**SUPPLEMENTAL
REPORT TO THE HEARING OFFICER**

DATE ISSUED:	November 20, 2025	
HEARING DATE:	December 2, 2025	AGENDA ITEM: 3
PROJECT NUMBER:	2018-000646-(3)	
PERMIT NUMBER(S):	Minor Coastal Development Permit ("CDP") RPPL2018000993	
SUPERVISORIAL DISTRICT:	3	
PROJECT LOCATION:	2425 Las Flores Road, Malibu (Assessor's Parcel Number 4448-026-050)	
OWNER:	Ricardo and Mariela Caravetta	
APPLICANT:	Amit Apel Design	
CASE PLANNER:	Shawn Skeries, Principal Regional Planner sskeries@planning.lacounty.gov

This agenda item is a request to authorize a new 4,821-square-foot, 18-foot-tall single-family residence with a 1,008-square-foot detached garage and other accessory development (“Project”) at 2425 Las Flores Road in the unincorporated Santa Monica Mountains (“Project Site”). At the initial public hearing on October 7, 2025, the Hearing Officer instructed the property owner and the applicant to reduce the Project’s building site area (“BSA”), and after hearing testimony from neighbors who opposed the Project, also recommended that the property owner and the applicant conduct some outreach and redesign the Project to address their concerns. The Hearing Officer then continued the public he

2429 LAS FLORES CYN,
MALIBU CA 90265
FIRE PLOT PLAN

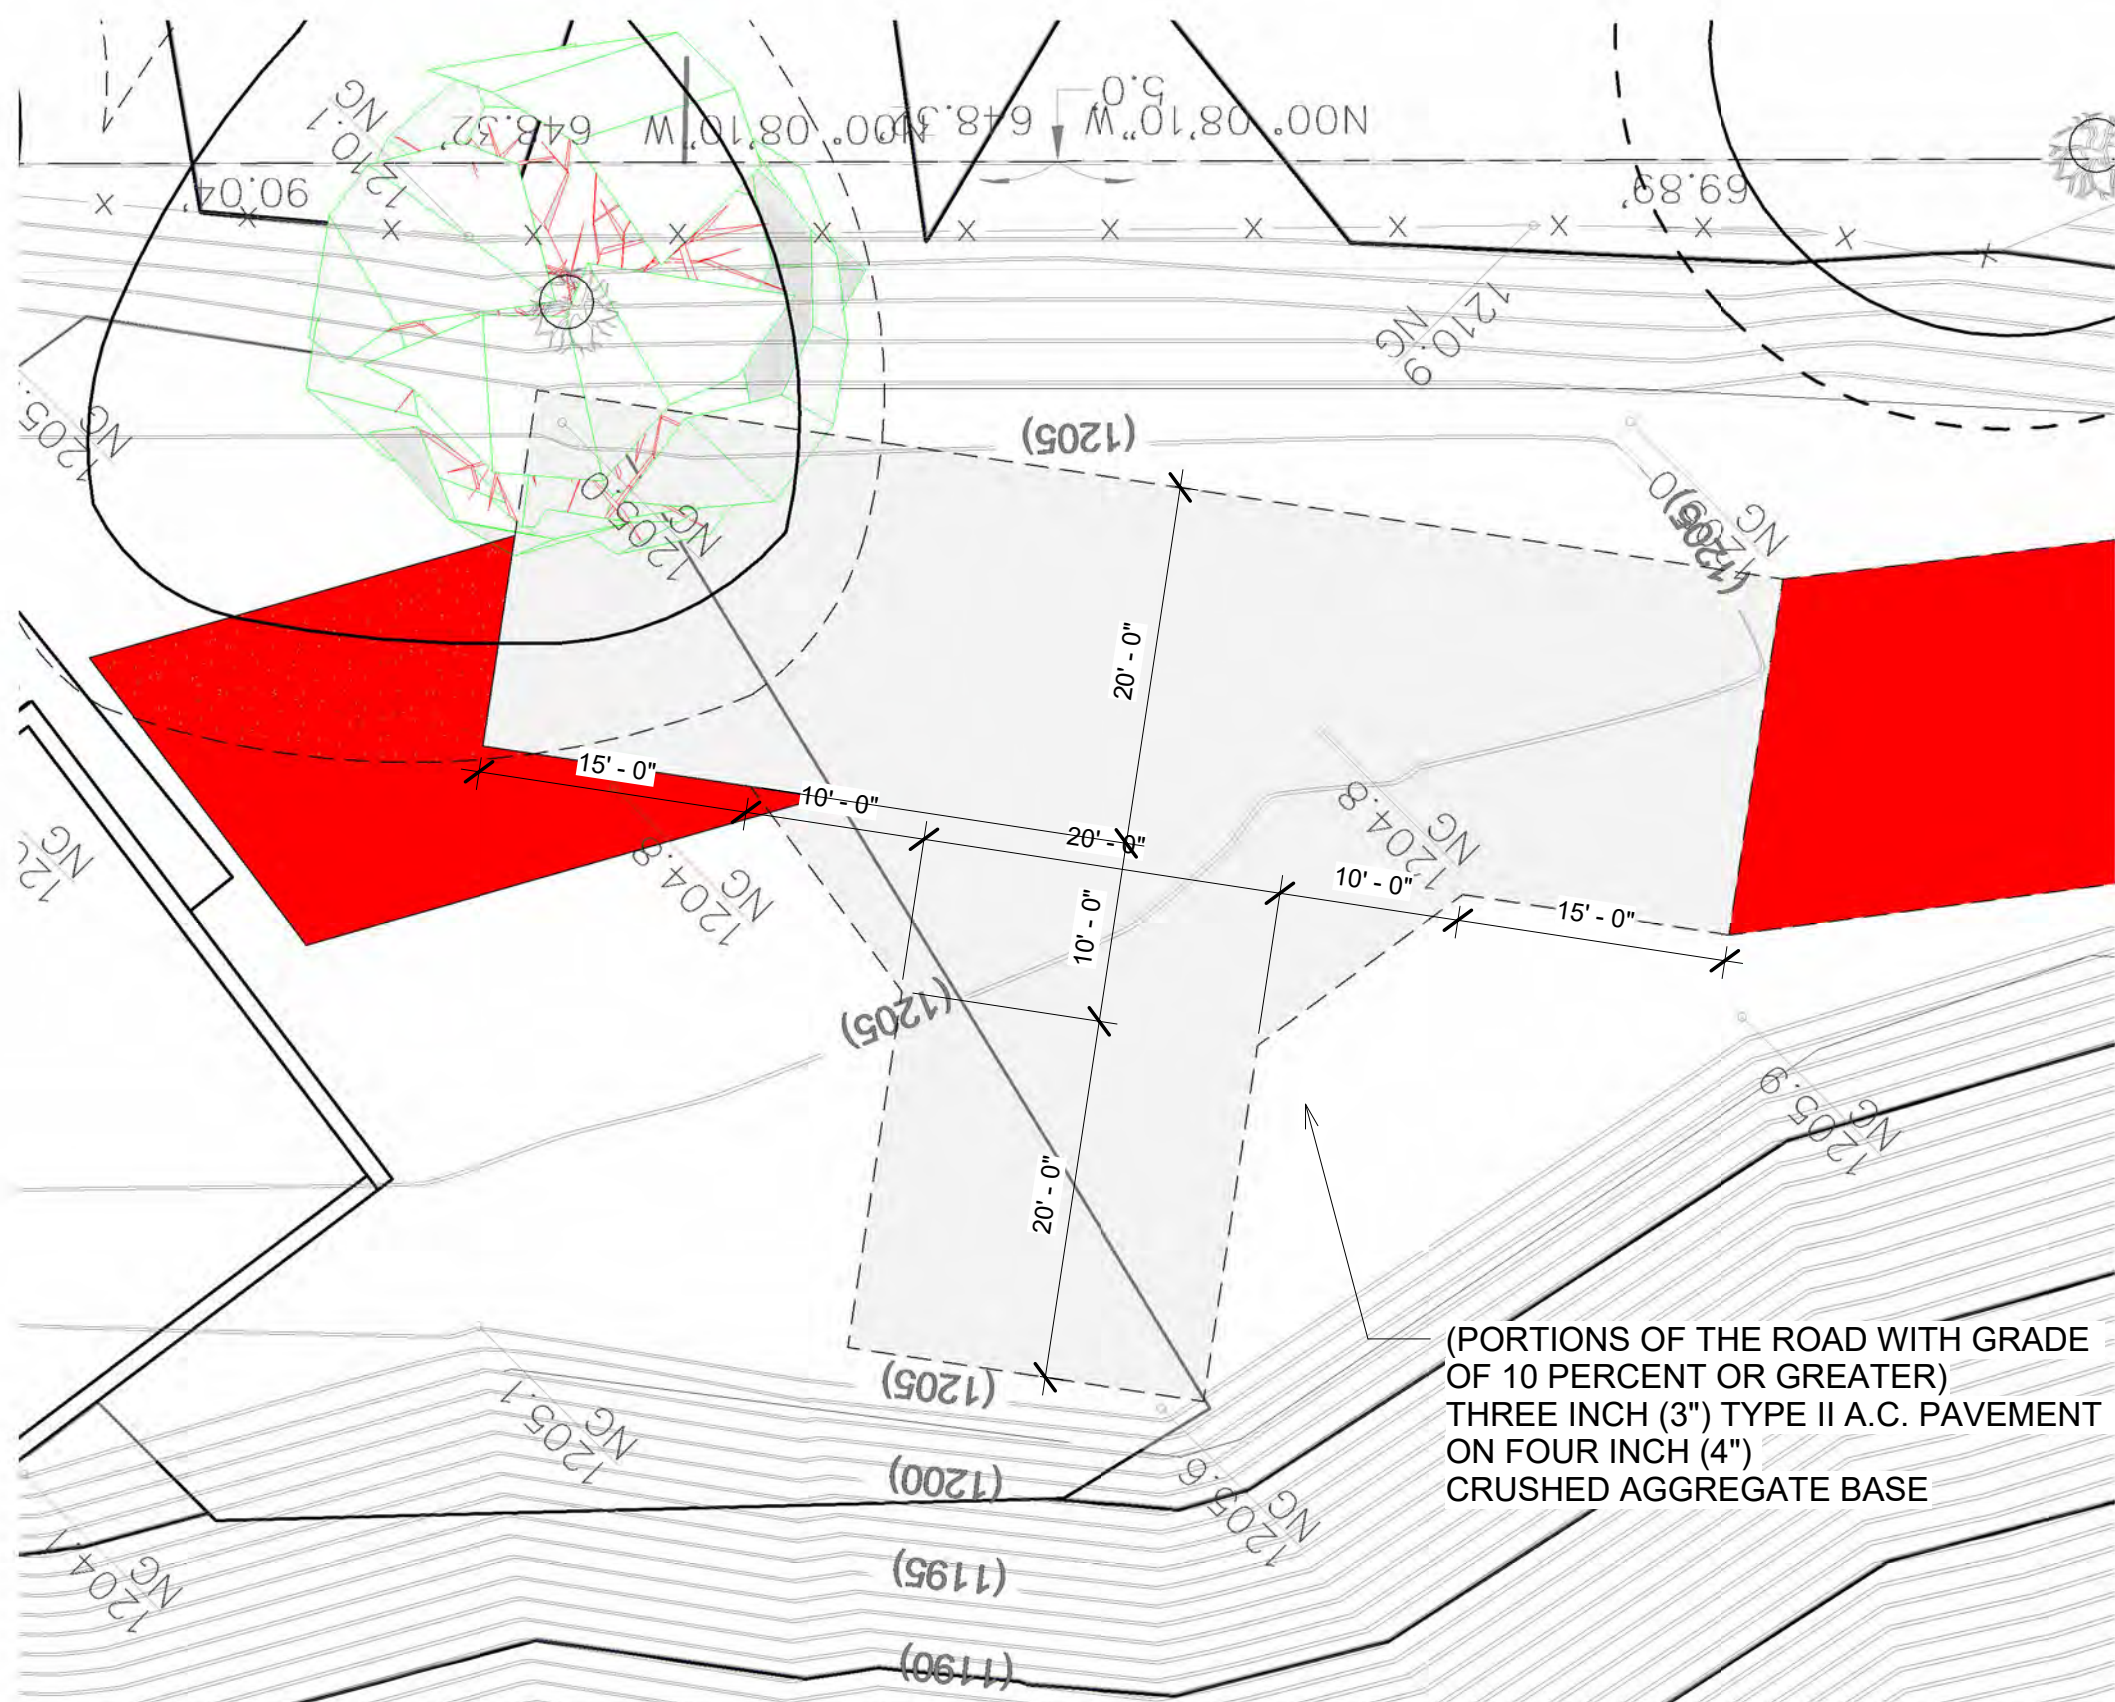
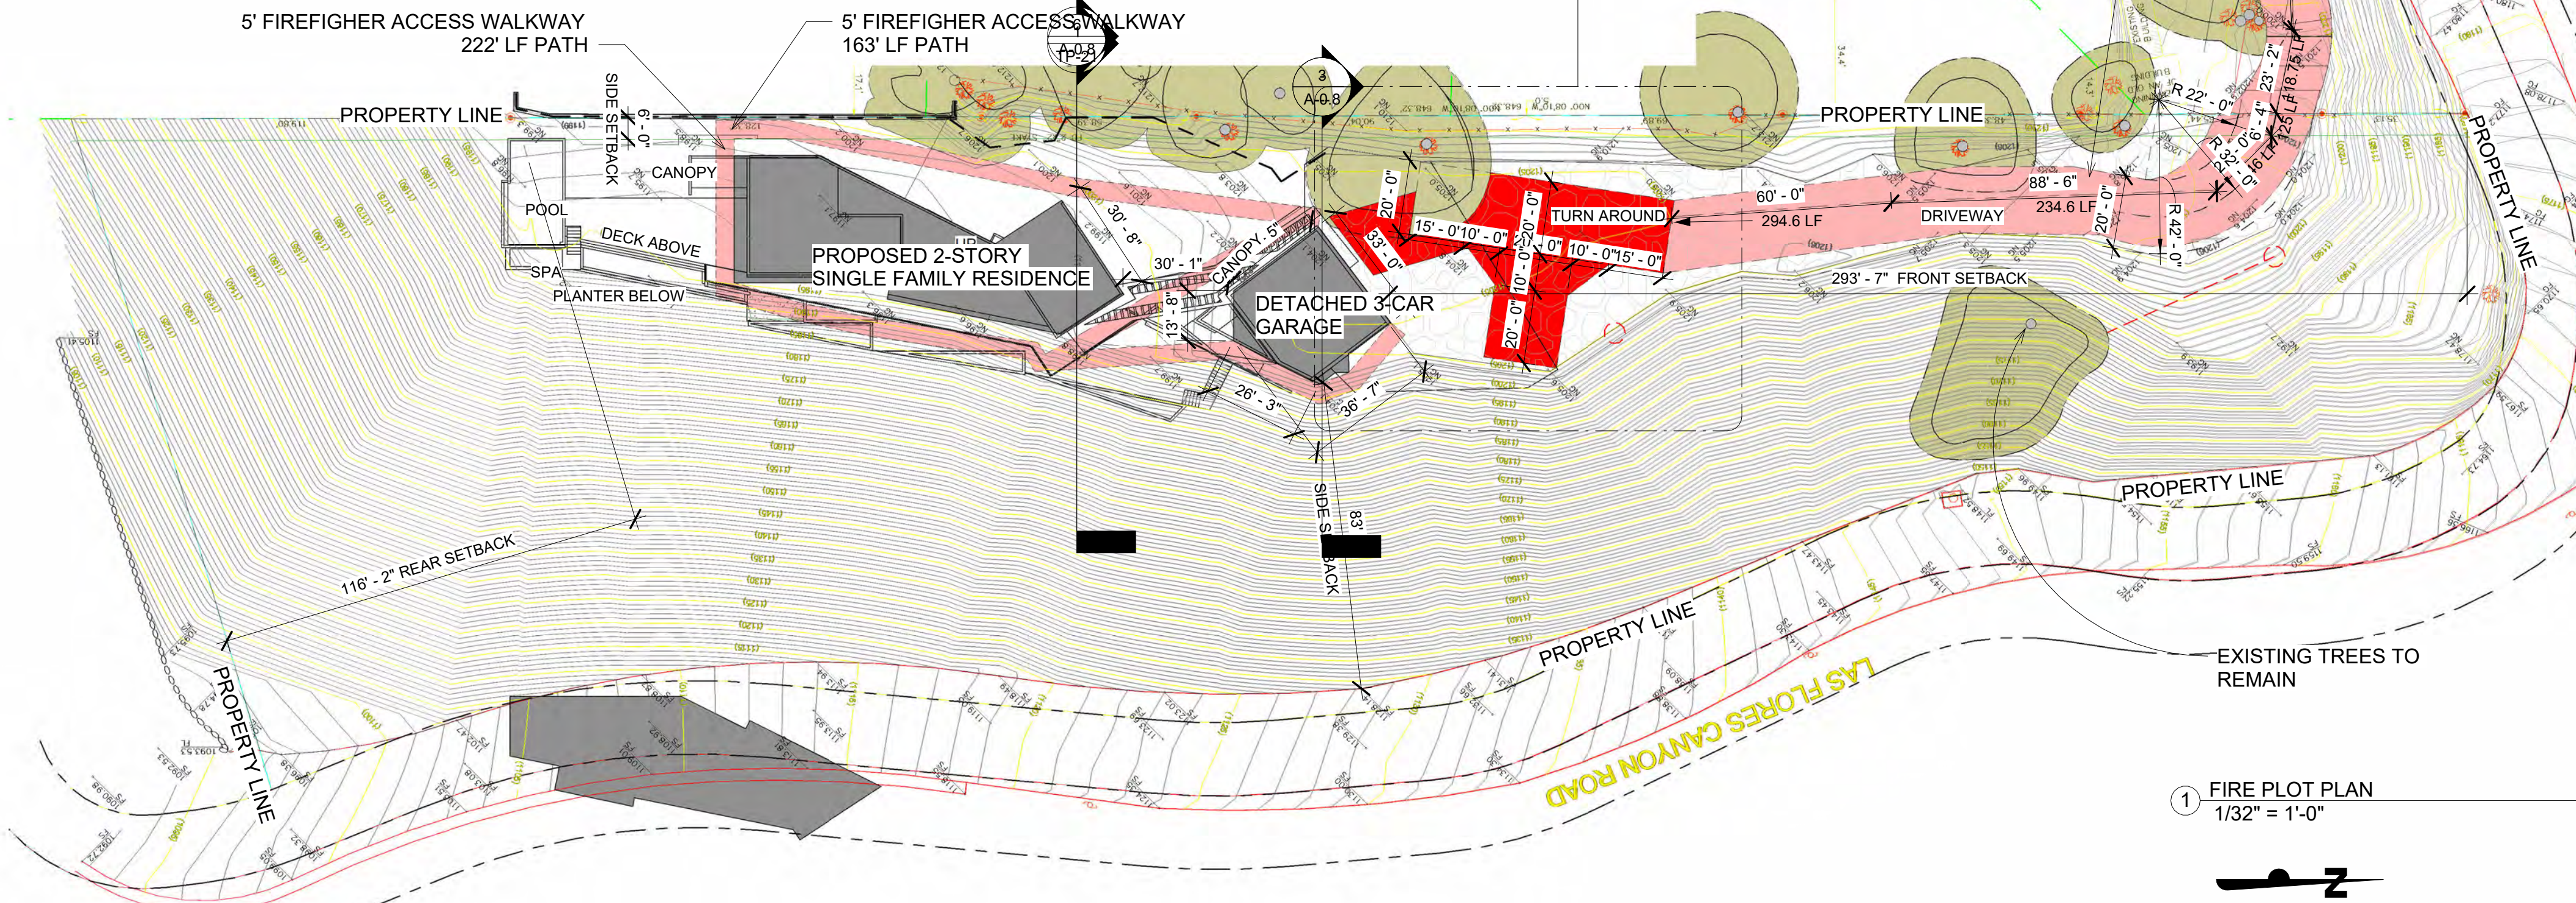
- The Fire Department's Land Development Unit has accepted the fire apparatus access roads as shown on the site plan. The fire apparatus access road shall comply with the following:

- Maintain a minimum width of 20ft, a reduction of not less than 18ft is accepted at the location shown on the site plan.
 - Provide an all-weather access surface to support a live load of 50,000lbs. Where the grade exceed 10%, pavement will be required.

- Shall provide a vertical clearance "clear to the sky" except underneath protected tree species where the vertical clearance shall not be less than 13ft 6in.

- Any turn shall provide a centerline turning radius of 32ft.
- Any proposed vehicular gate(s) shall not obstruct any portion of the required fire apparatus access road, shall be equipped with an approved locking device, and shall be designed in compliance with the LA County Fire Code requirements.

1 SITE PLAN
1/8" = 1'-0"

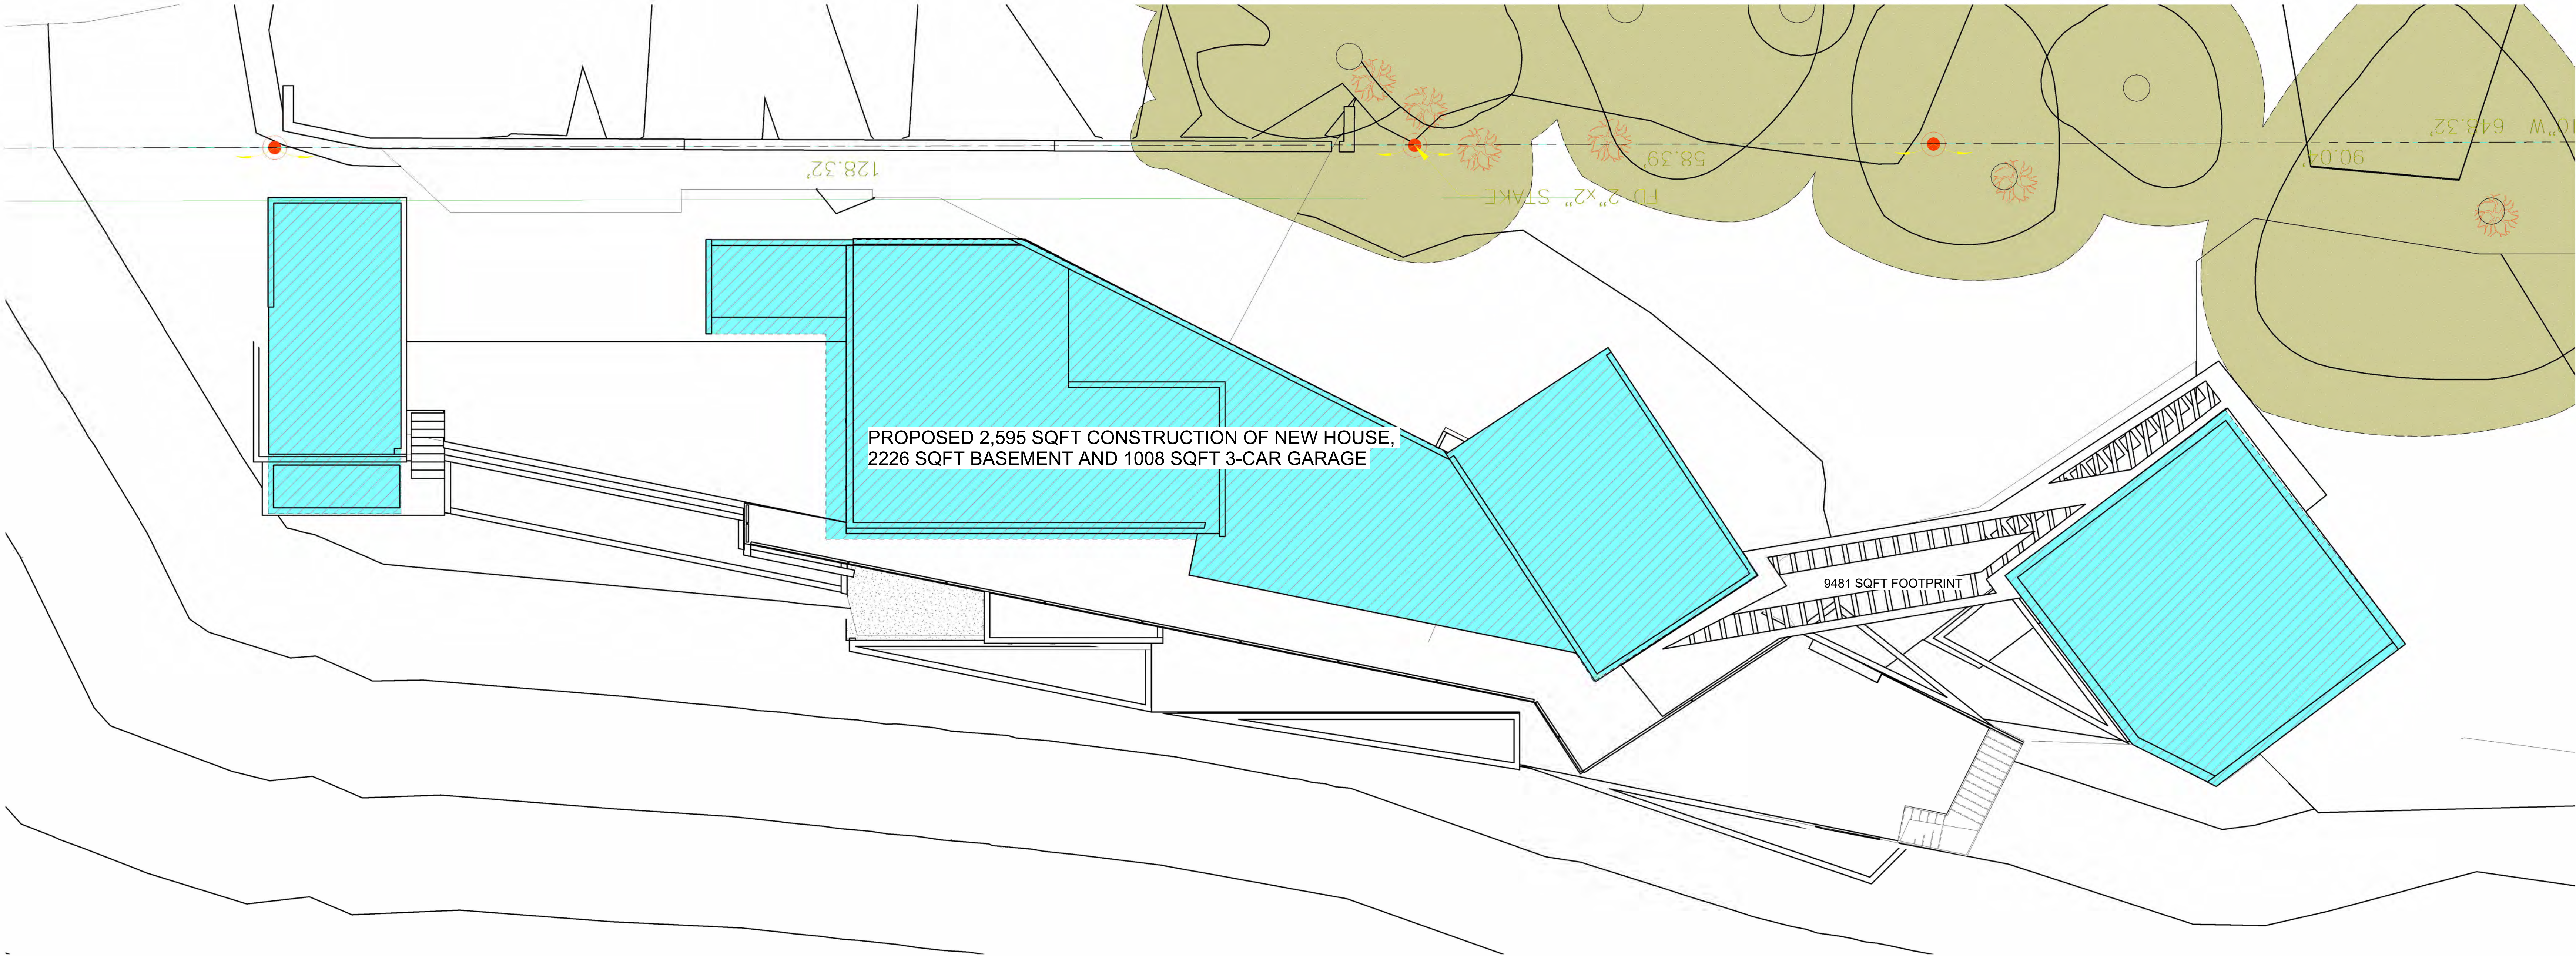
- The side yard setback from the residence to an existing retaining wall that runs along the side property line to the north was expanded from six feet to 10 feet and six inches.
- The square footage of the single-family residence’s main floor was reduced by 7.2 percent.
- The square footage of the detached garage was reduced by 2.4 percent.
- The height of a canopy cover over an outdoor seating area was reduced.
- Hardscaping was reduced, which helped reduce the overall BSA.
- The total grading amount was reduced from 2,413 cubic yards to 2,279 cubic yards.

Modification Proposal Sketch at Mr. Silvers Request

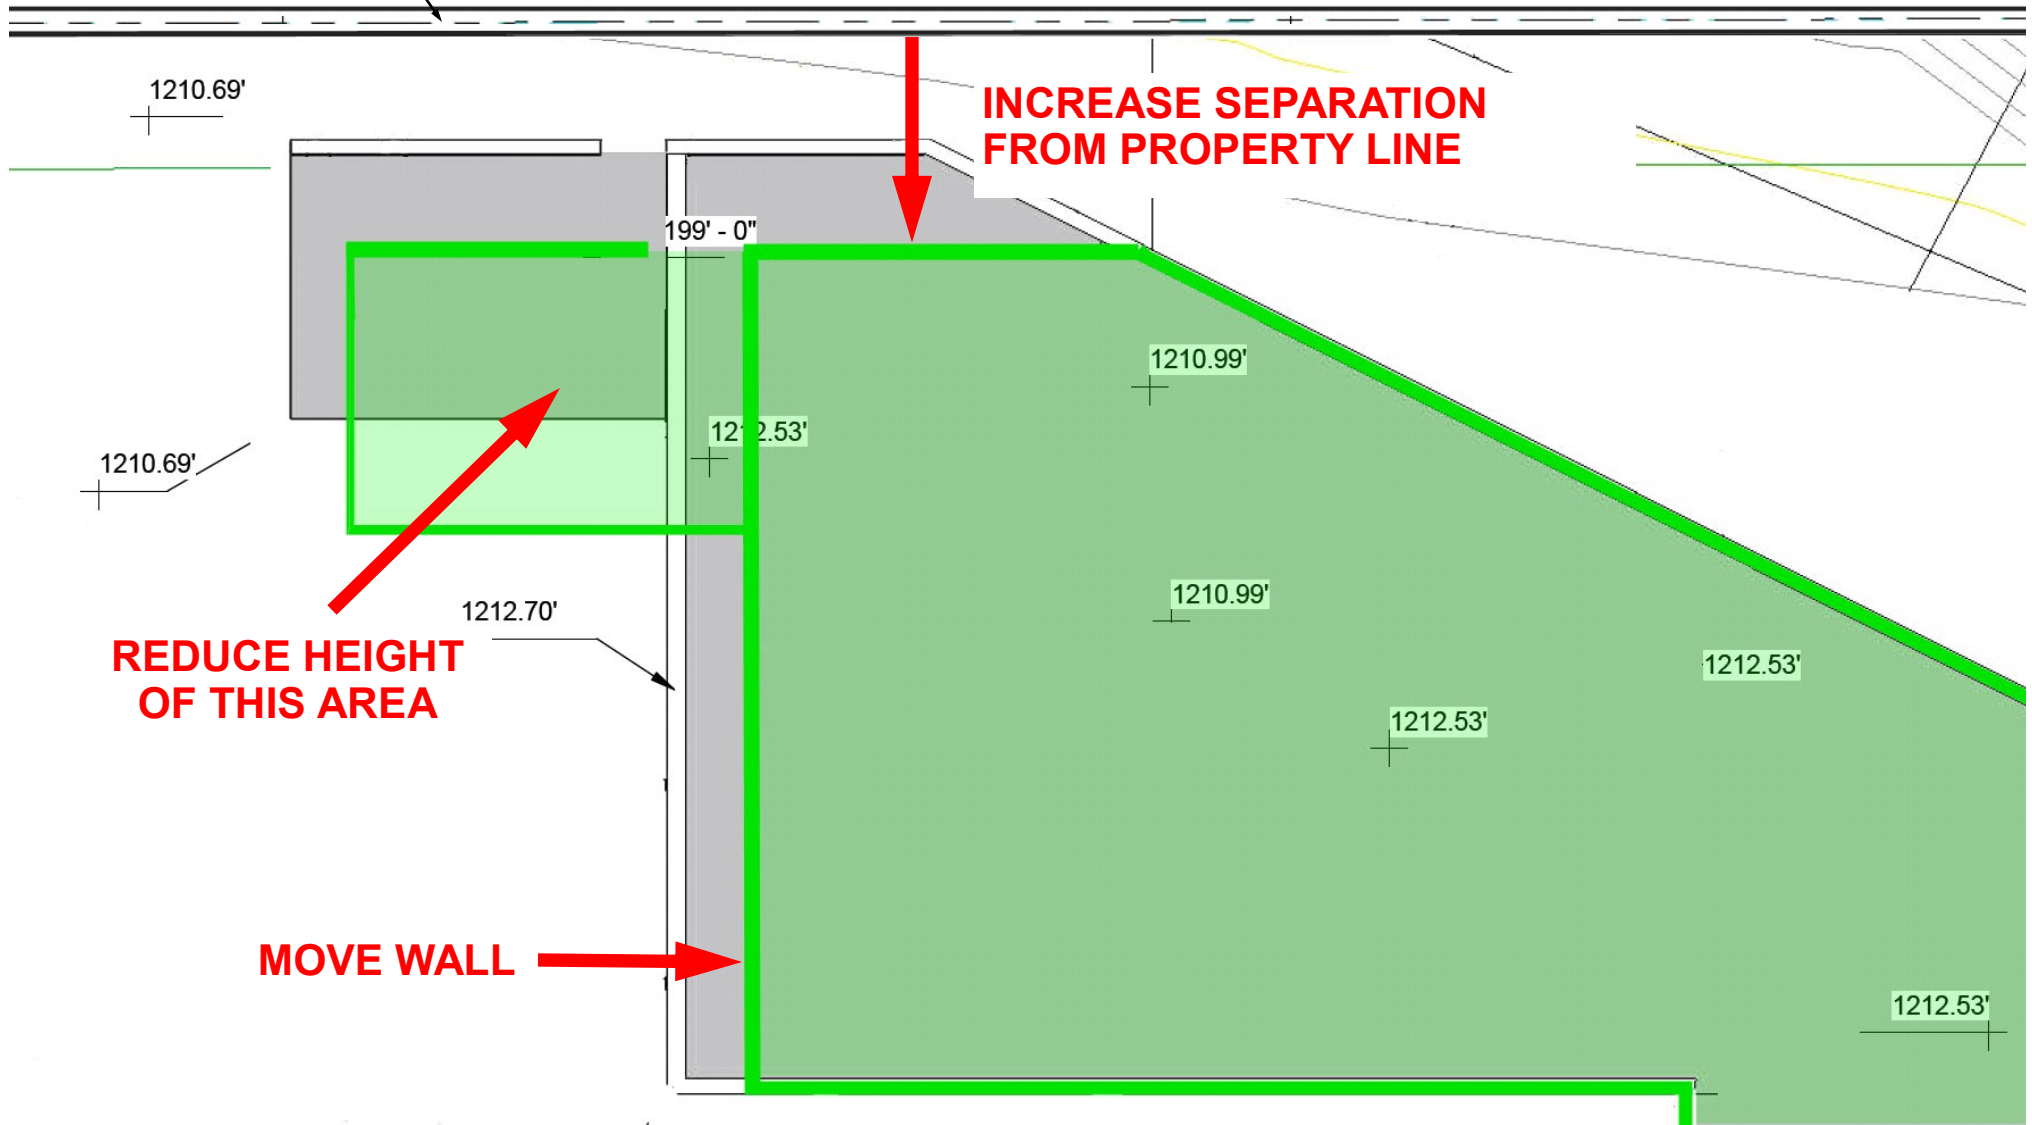
REDUCE HEIGHT
OF THIS AREA
